Addendum #01

Date: November 28, 2022

Project: Longview School District HVAC Chiller Replacements and Indoor Air Quality Improvements

2 CRICKET DETAIL - DOWNSLOPE
SCALE: 1 1/2" = 1'-0"

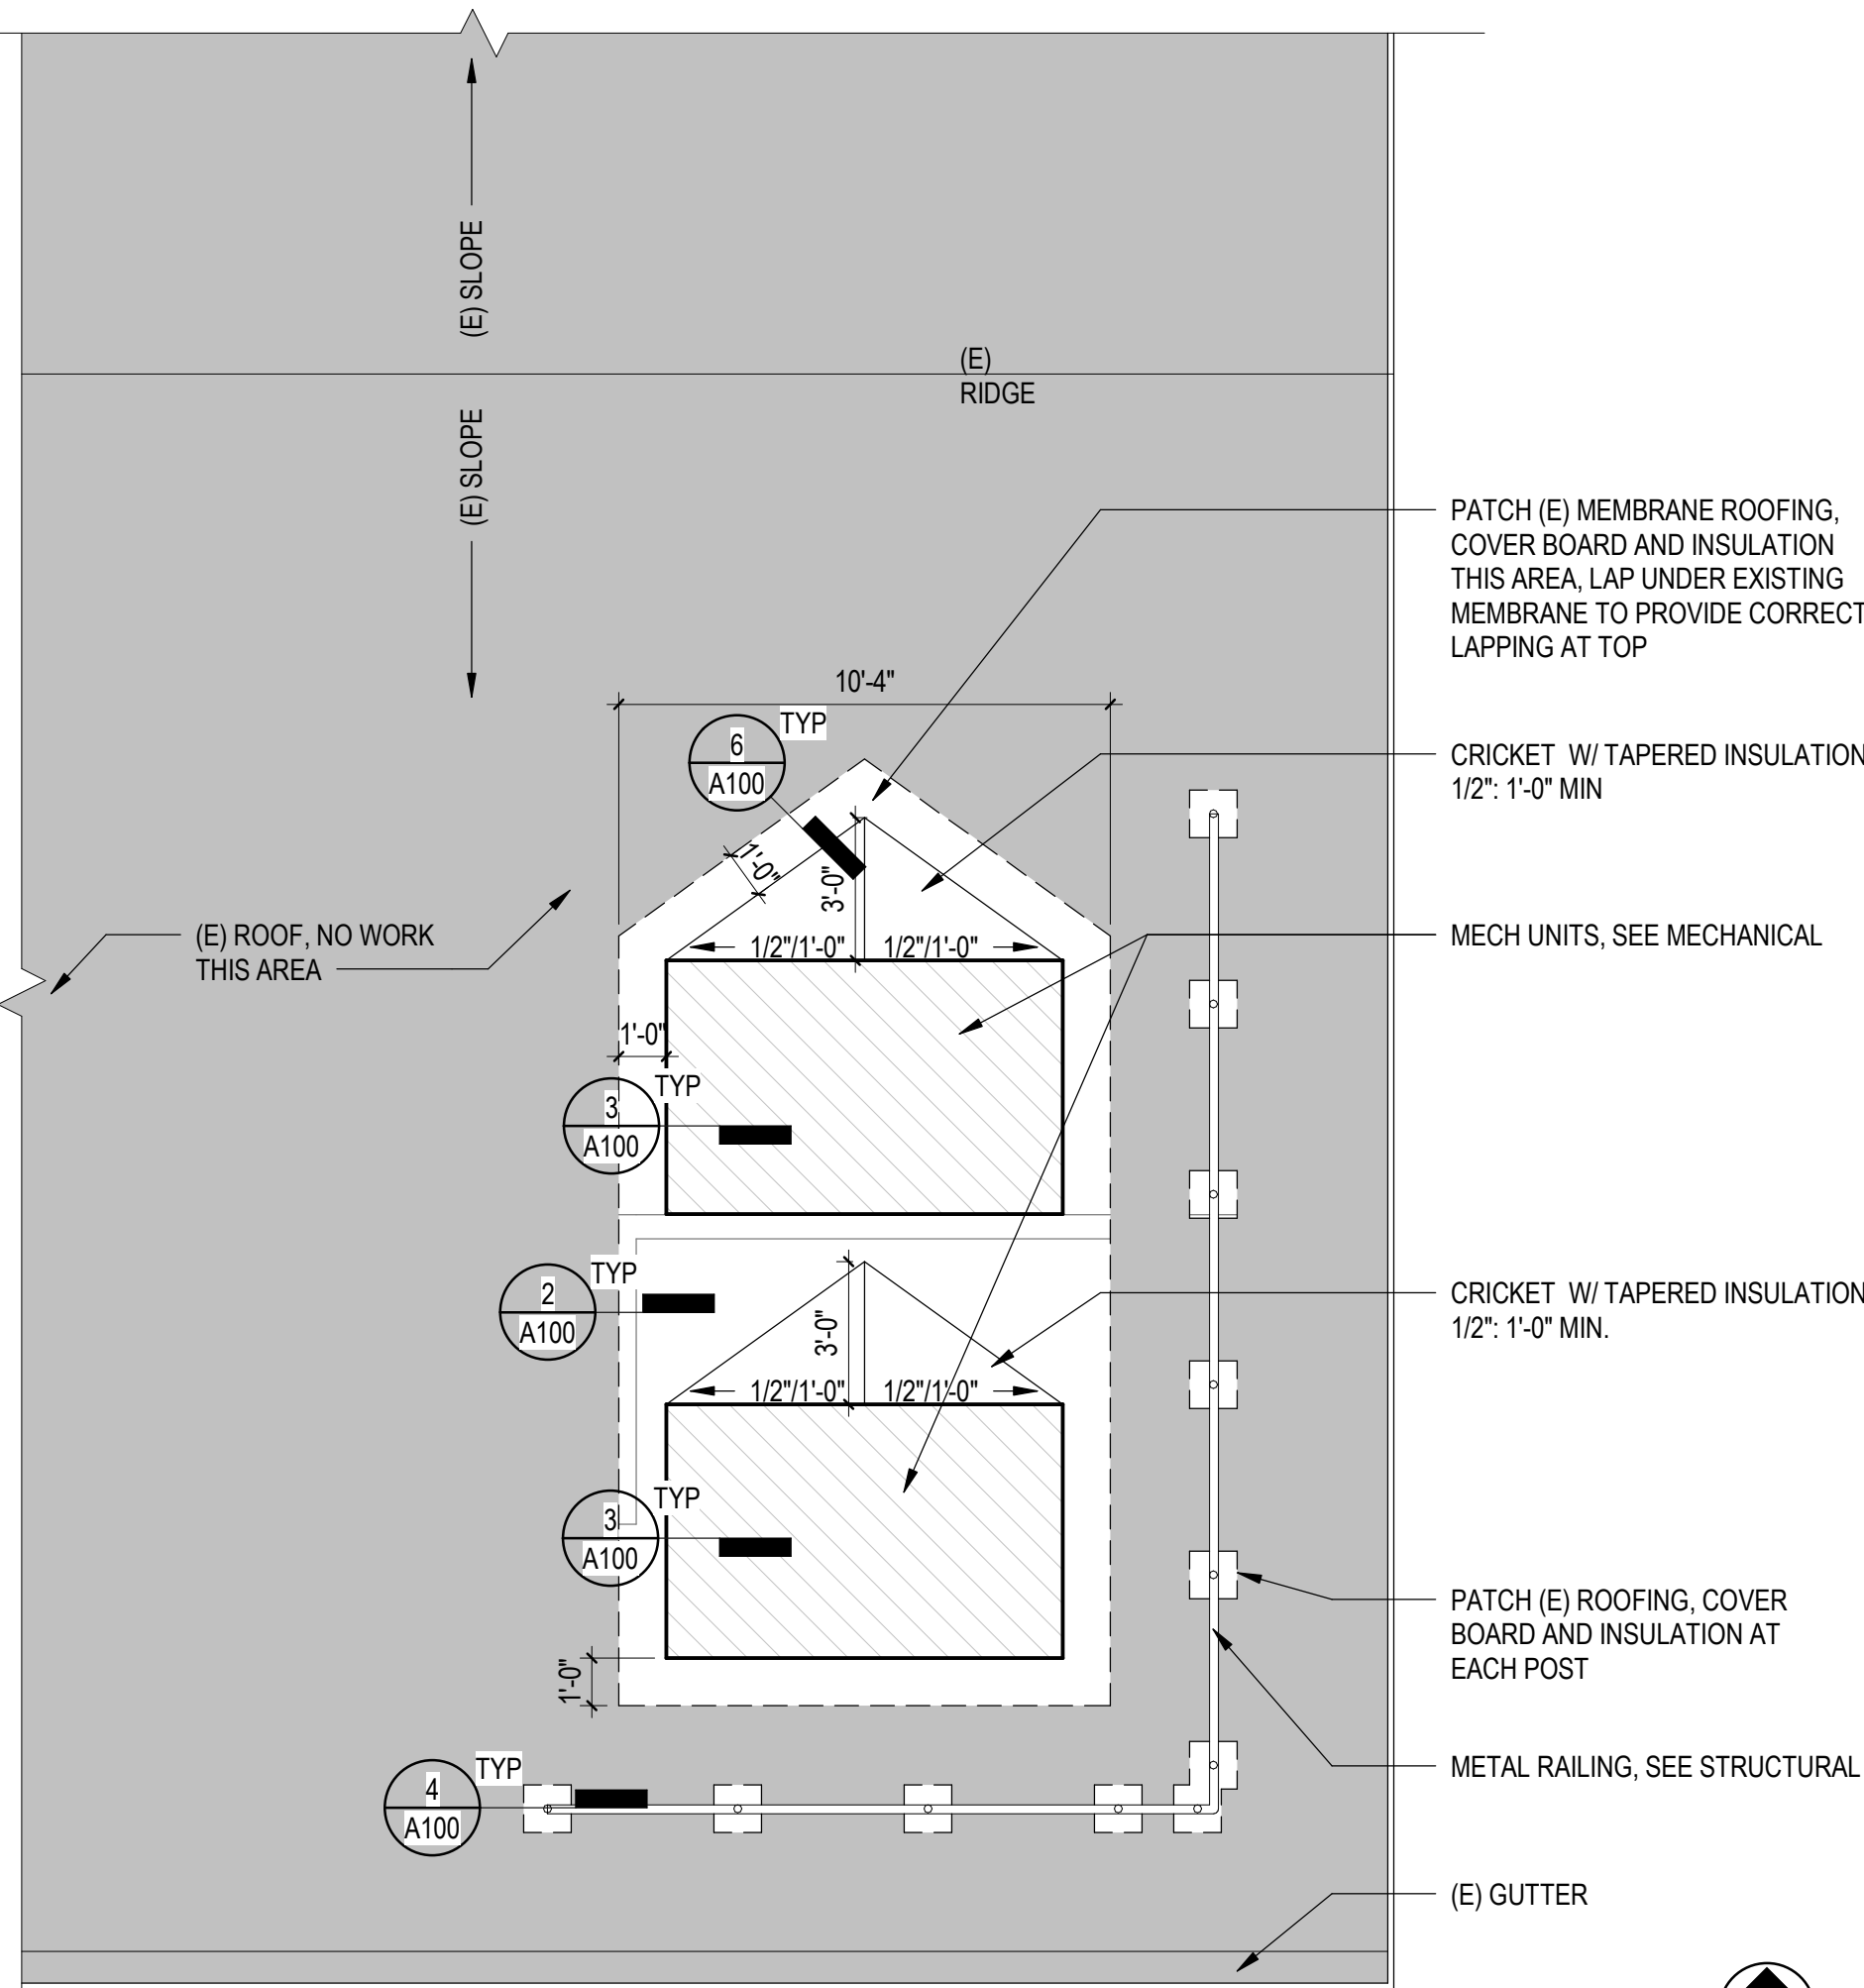
Add. #01 **ADD:** SHEET A100 – COLUMBIA HEIGHTS PLAN in its entirety per attached Sheet A100 to clarify painting of interior elements, roof patching scope, and patching of interior walls, floor, and ceiling.

DWG. #: **ADA-002**
JOB #: 22200
DRAWN BY: EP
DATE: 11/28/22
REF. DOC.: ADDENDUM 01

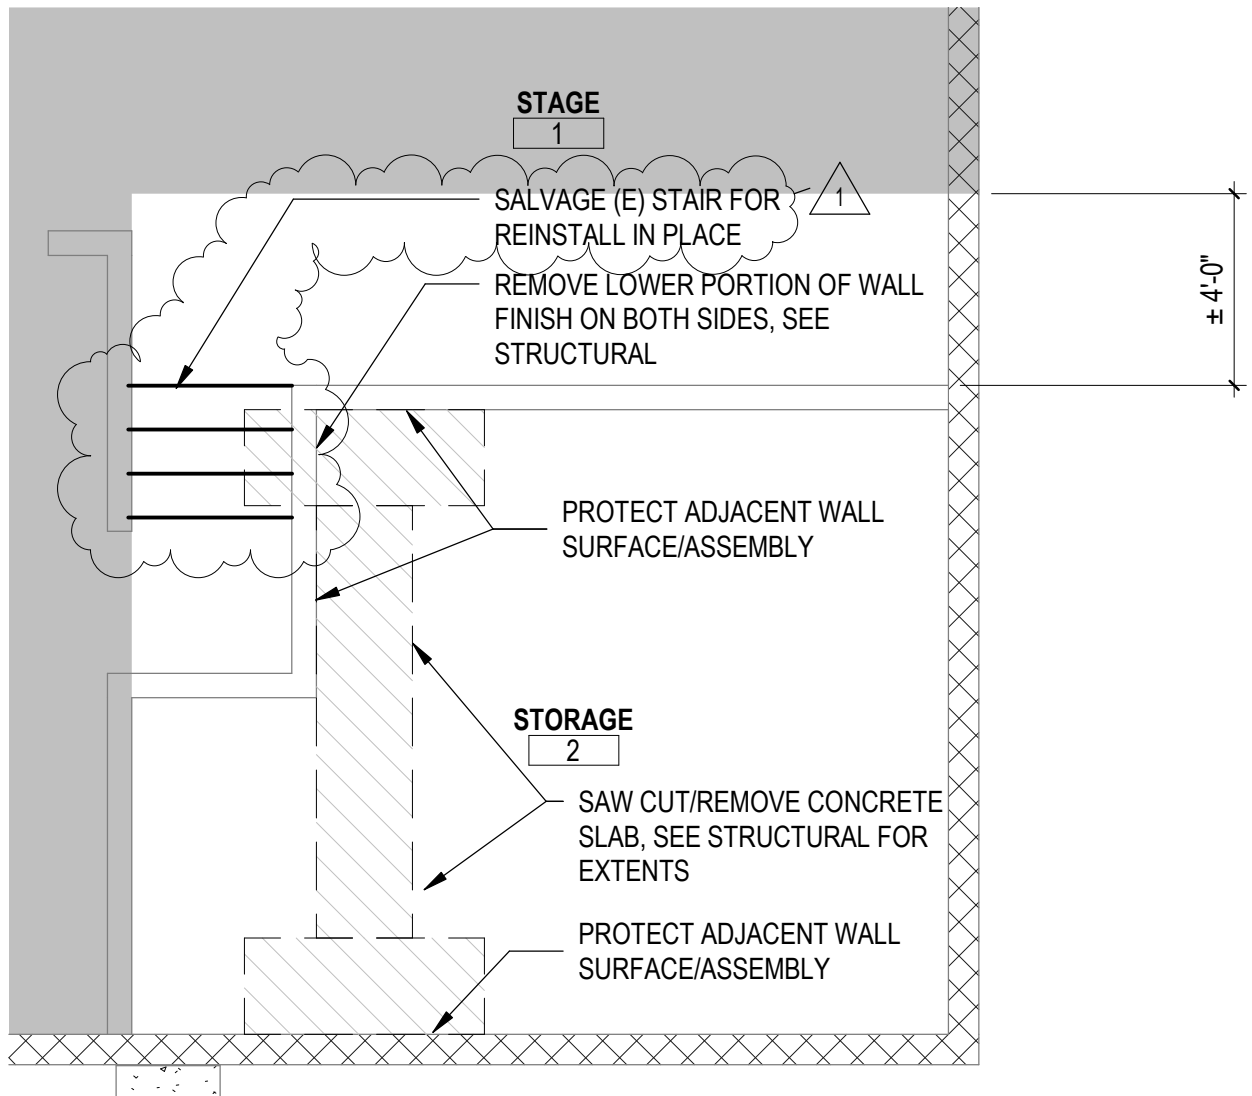
Add. #01 **REVISE:** Detail 1 – LEVEL 1 – COLUMBIA HEIGHTS ENLARGED DEMO PLAN per attached ADA 002.

DWG. #: **ADS-001**
JOB #: 22220.00
DRAWN BY: AM
DATE: 11/28/22
REF. DOC.: ADDENDUM 01

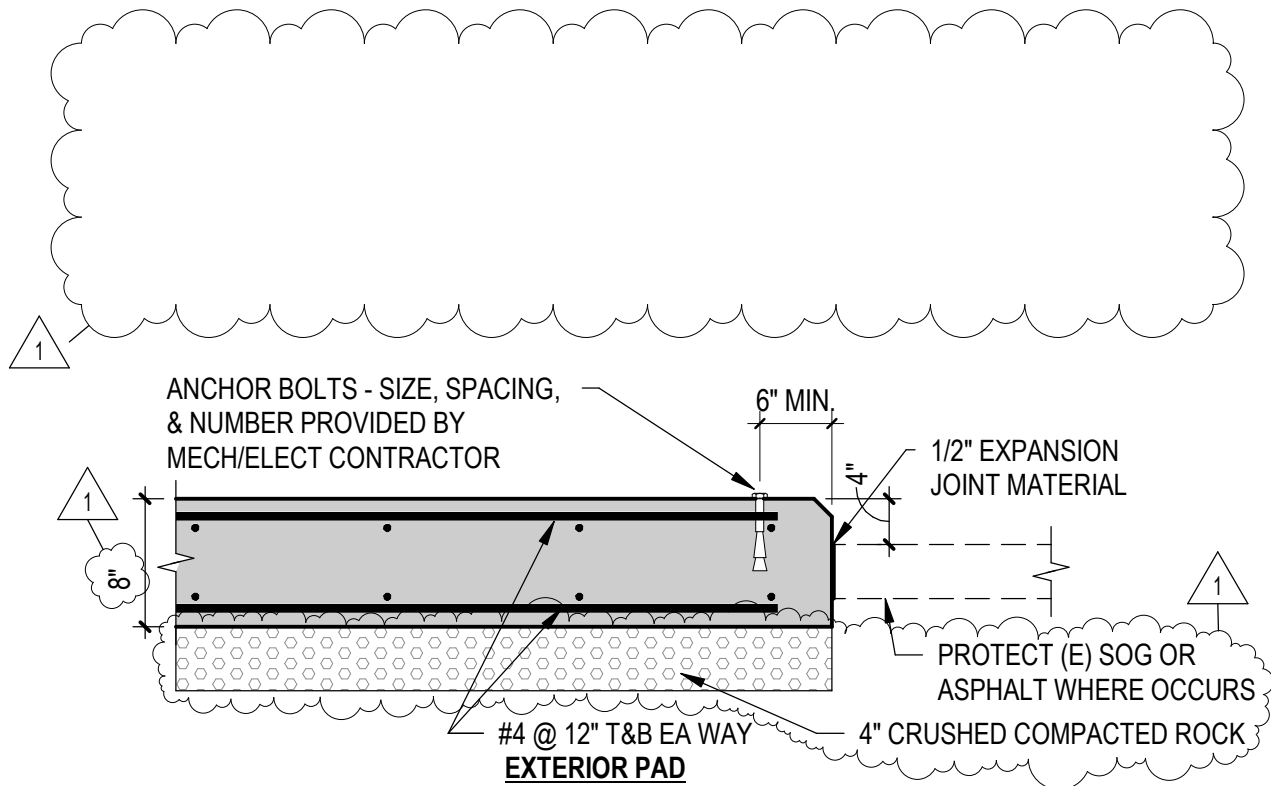
- Item #S01 S1-3 – PLAN VIEWS AND DETAILS
Add. #01 **REVISE:** text callout on detail 2/S1-3 from “WALL FINISH TO CL GUARDRAIL, GC VERIFY” to “**WALL FINISH TO CL GUARDRAIL = 1'-0", GC VERIFY**”.
- Item #S02 S1-3 – PLAN VIEWS AND DETAILS
Add. #01 **REVISE:** detail 13/S1-3 per attached sketch ADS-001.

Add. #01 **ADD:** note to chiller at Partial Site Plan – Mech/Elec Demo: "*DEMO EXISTING CONCRETE PAD AND ASPHALT TO NEW CHILLER PAD EXTENT. REFERENCE STRUCTURAL DETAIL 13 / S1-3.*"

Add. #01 **ADD:** note to chiller at Partial Site Plan – Mech/Elec Demo: "DEMO EXISTING CONCRETE SLAB TO NEW CHILLER PAD EXTENTS. REFERENCE STRUCTURAL DETAIL 13 / S1-3."

- Item #M12 ME3.1 – SCHEMATICS AND DETAILS
Add. #01 **REVISE:** chiller housekeeping pad callout at Detail 1 / ME3.1 to read: “CONCRETE CHILLER PAD, REFERENCE STRUCTURAL DETAIL 13 / S1-3.”
